UNITED STATES PATENT AND TRADEMARK OFFICE

APPLICATION NO.	FILING DATE	FIRST NAMED INVENTOR	ATTORNEY DOCKET NO.	CONFIRMATION NO.
10/774,682	02/09/2004	Thomas Rueckes	112020.129 US2 (NAN-6)	9428
23483	7590	11/21/2006	EXAMINER	
WILMER CUTLER PICKERING HALE AND DORR LLP			COLEMAN, WILLIAM D	
60 STATE STREET			ART UNIT	
BOSTON, MA 02109			PAPER NUMBER	
			2823

Office Action Summary

DETAILED ACTION

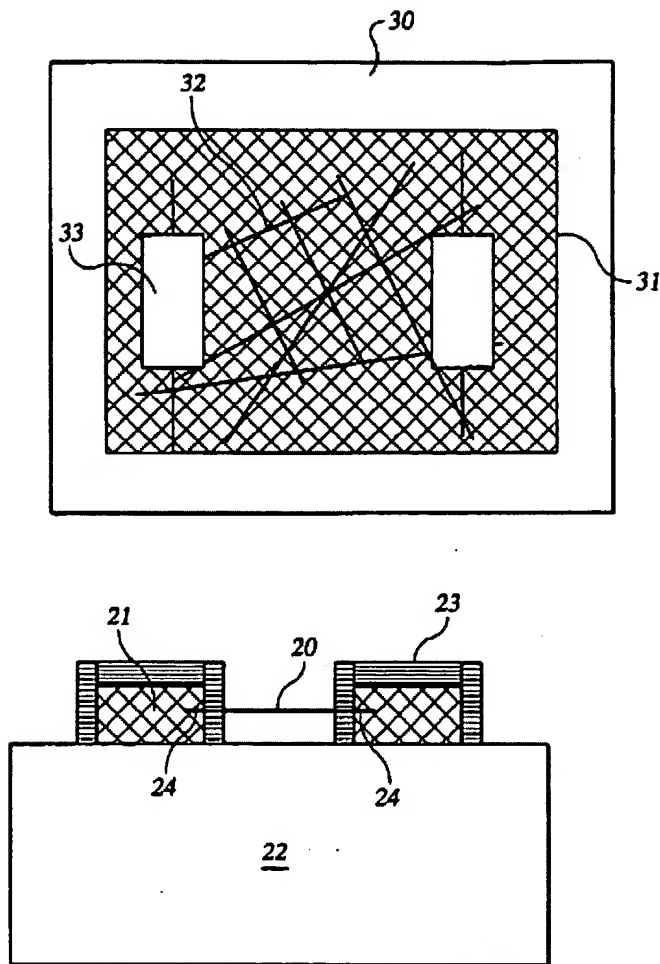
4. Claims 1-2, 4-7 and 9-15 are rejected under 35 U.S.C. 102(e) as being anticipated by Dai et al., U.S. Patent 6,528,020 B1.

5. Pertaining to claim 1, Dai teaches an assembly including a substrate **30** and a conductive trace **32** on the substrate, wherein the trace includes a plurality of unaligned nanotubes for providing a plurality of conductive pathways along the trace (it is well known that carbon nanotubes are conductive, see column 4, line 17).

7. Pertaining to claim 4, Dai teaches the assembly of claim 1 wherein the nanotubes have different lengths (see FIG. 3B above).
8. Pertaining to claim 5, Dai teaches the assembly of claim 1 wherein the nanotubes include nanotubes having a length shorter than the length of the article (although not drawn to scale, it appears that the substrate is larger than the length of the carbon nanotubes).

12. Pertaining to claim 10, Dai teaches the assembly of claim 6 wherein the nanotubes include a length shorter than the length of the ribbon (see FIG. 3B).

13. Pertaining to claim 11, Dai teaches an assembly including a substrate **30** and a conductive trace of predefined shape (see FIG. 1C), the conductive trace being over the substrate, the conductive trace including a plurality of unaligned nanotubes for providing a plurality of conductive paths along the extent of the trace.

14. Pertaining to claim 12, Dai teaches an assembly including a substrate, at least one metal electrode **33**, and a conductive trace of predefined shape, the conductive trace being over the substrate, the conductive trace including a plurality of unaligned nanotubes for providing a plurality of conductive paths along the extent of the trace, and the metal electrode being over at least a portion of the conductive trace, the metal electrode being formed by a metallization step (see FIGS. 1A-1C).

15. Pertaining to claim 13, Dai teaches a wafer substrate structure having a non-woven fabric of unaligned nanotubes substantially parallel to and covering a major surface of the wafer substrate and wherein the nanotubes of the fabric are arranged in accordance with inherent self-assembly traits of the nanotubes (see FIG. 1C).
